AMENDMENTS TO THE DRAWINGS:

Amendments to the drawings are annexed to this Communication in the Appendix.

FIG.1

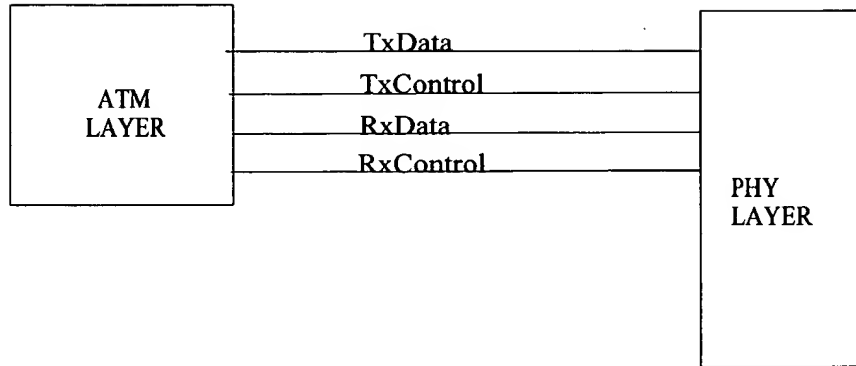
Please add the term “*Prior Art*” to Figs. 1-4.

PRIOR
ART
